early design guidance #2

Property Address:
400 Fairview Ave. N
Seattle, WA
DPD Project#: 3013102

Owner: Skanska USA Commercial Development Inc.
Owner / Applicant: Murphy McCullough

Architect: SkB Architects
2333 3rd Ave. Seattle, WA 98121
Architect Contact: Brian Collins-Friedrichs
206.903.0575
bcollinsfriedrichs@skbarchitects.com

upper building plan diagrams

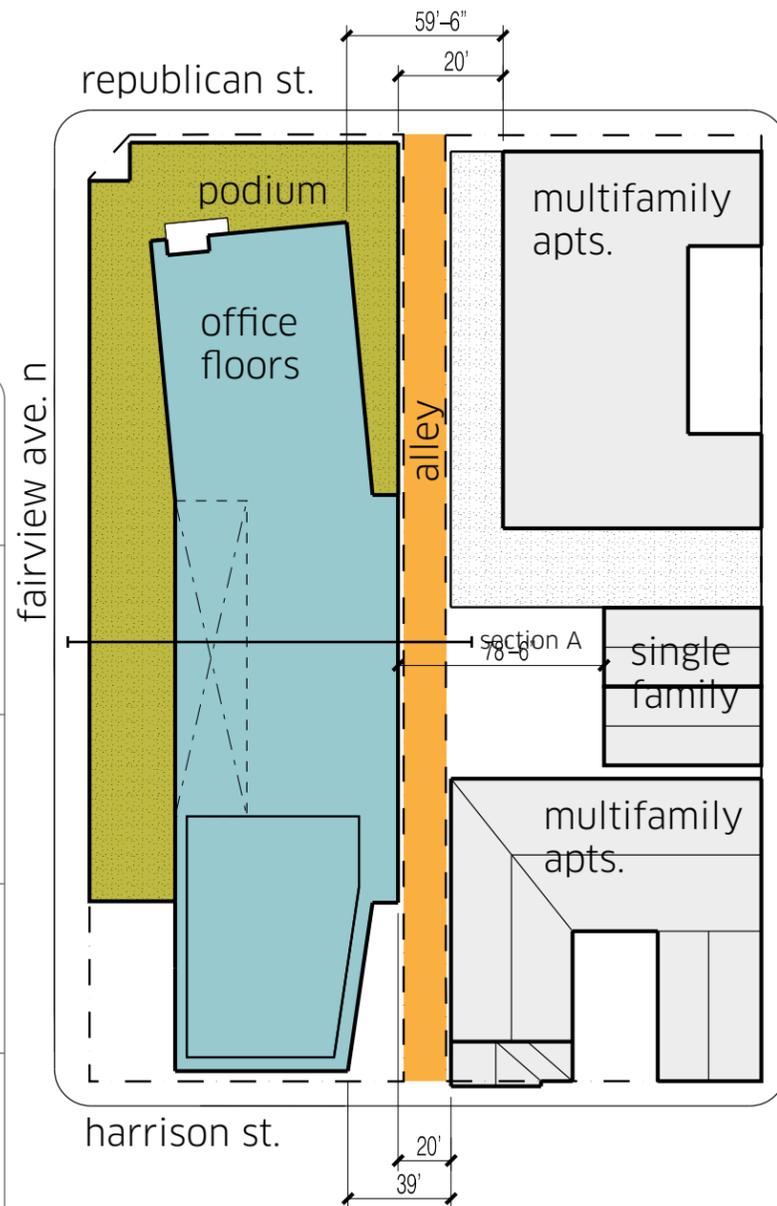
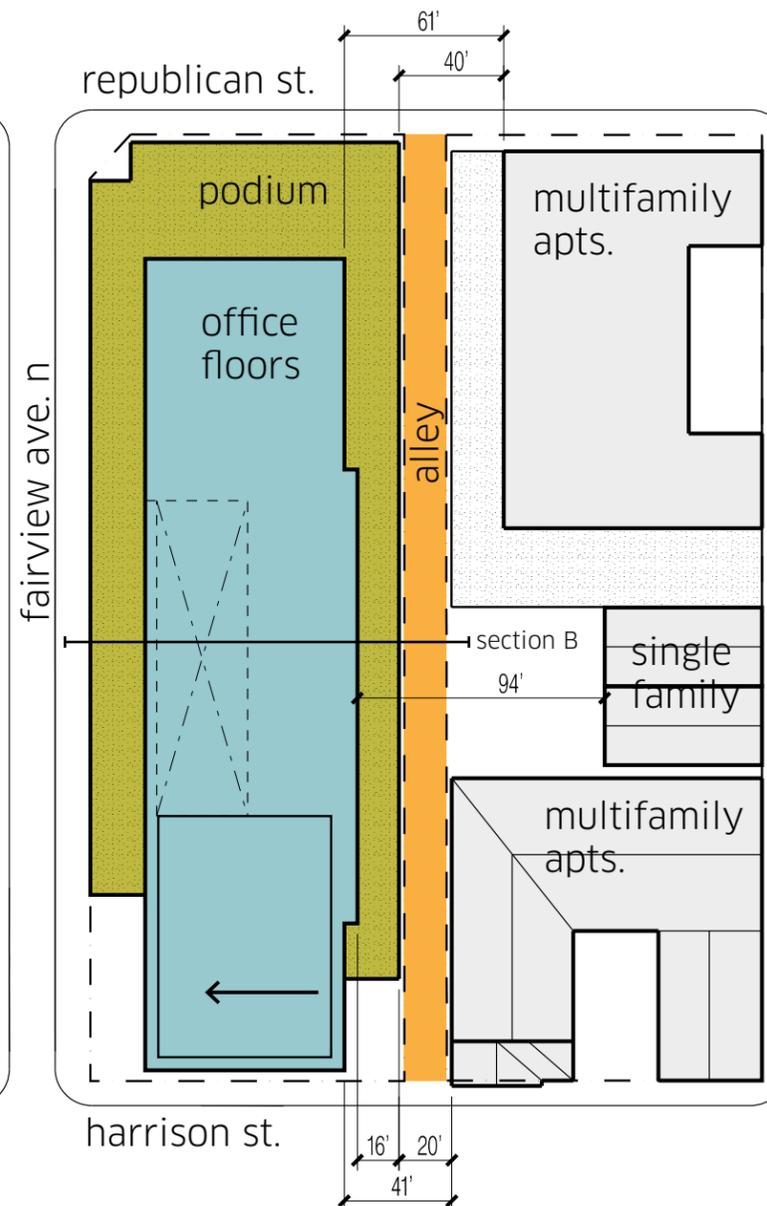
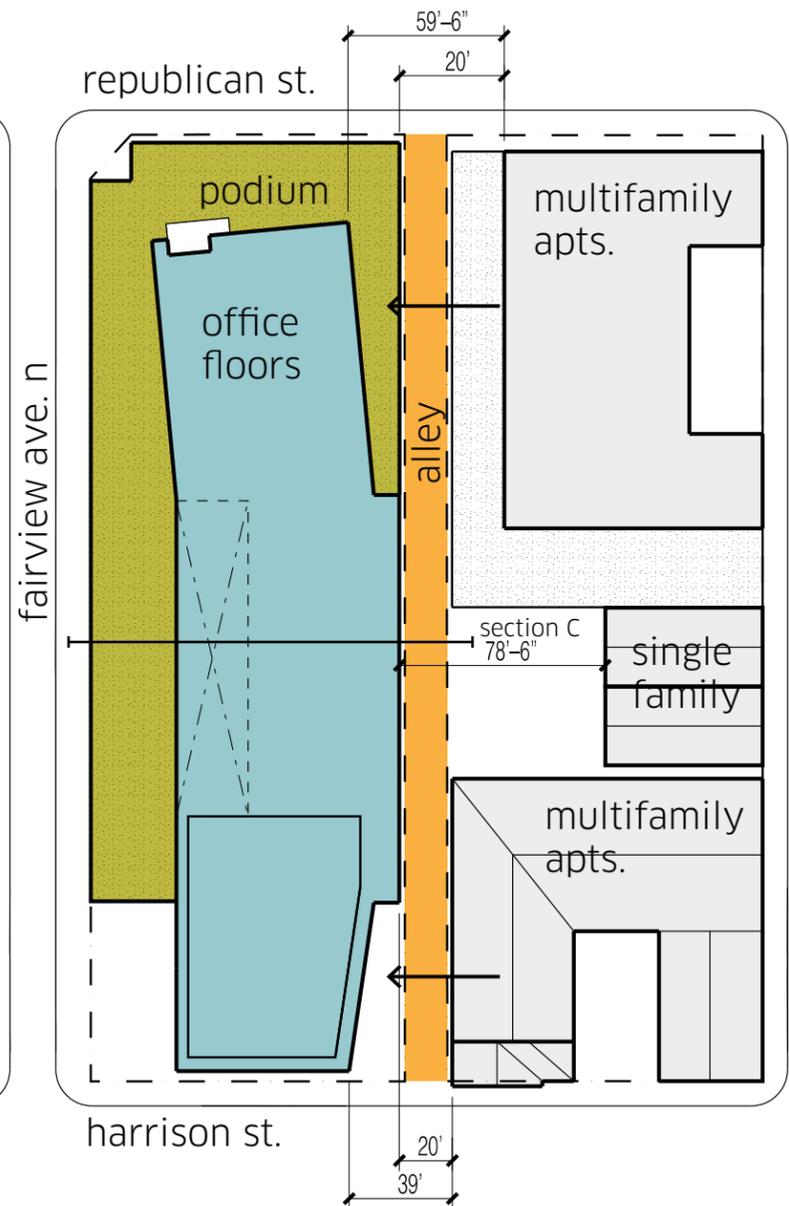
recommendation checklist

✓	a. Test massing moved to west
✓	b. Address "human activity" at street
✓	c. Reduce scale of facades
✓	d. Minimize glare
✓	e. Develop east facade treatment
✓	f. Keep massing setback at alley

- office floor massing at alley
- 5' setback at North and South end
- best light quality for plaza and markethall

- office floor massing at center
- equal setbacks east and west
- marginal light quality for markethall
- inefficient floor plates
- reduced southwest plaza

- office floor massing at alley
- greater setback at North and South end for light and air
- best light quality for plaza and markethall

sun / shadow study

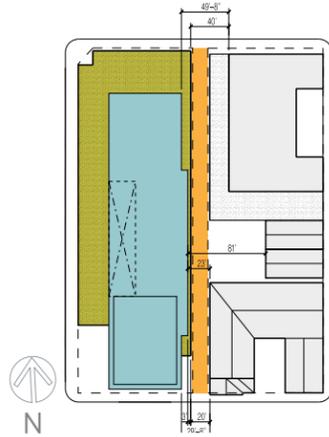
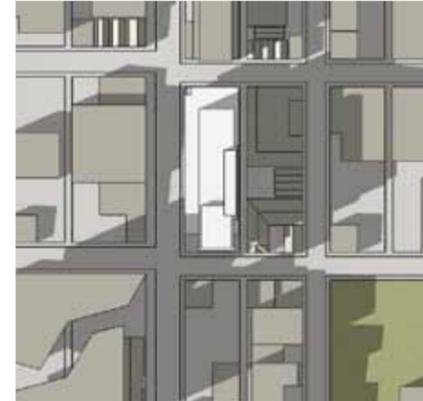
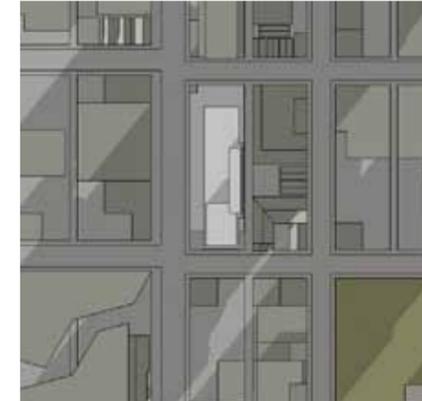
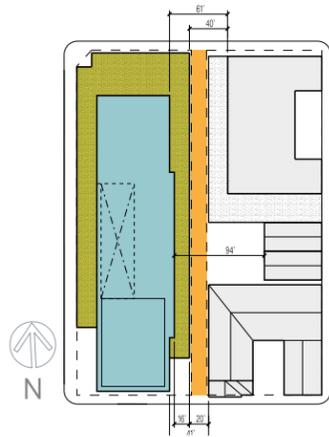
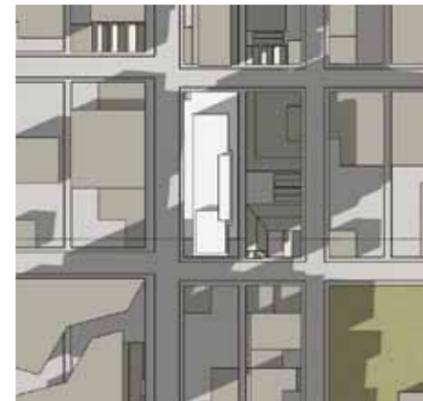
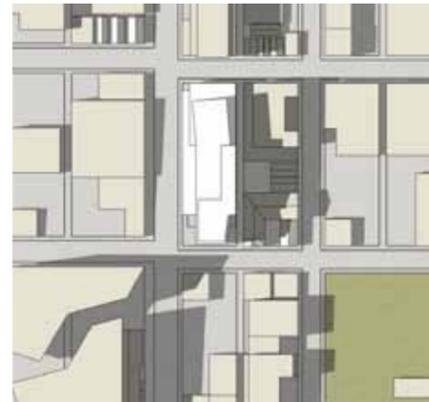
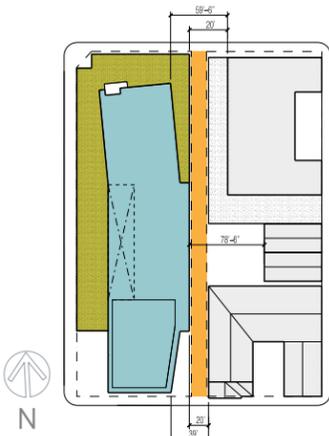
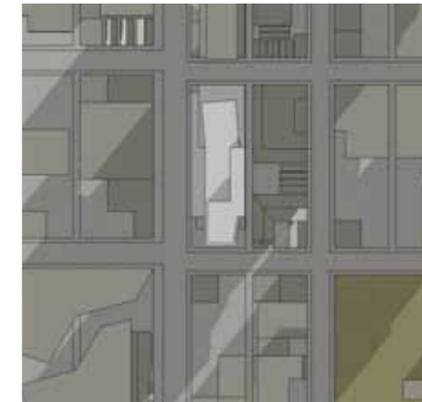
- Shadow cast by 400
- More sunlight to others (to west)
- Less sunlight to residences (to east)

- Shadow cast by 400
- Extra sunlight to residences: 15 minutes more per day (to east)
- Less sunlight to others (to west)

- Shadow cast by 400
- More sunlight to residences (to east)
- More sunlight to others (to west)
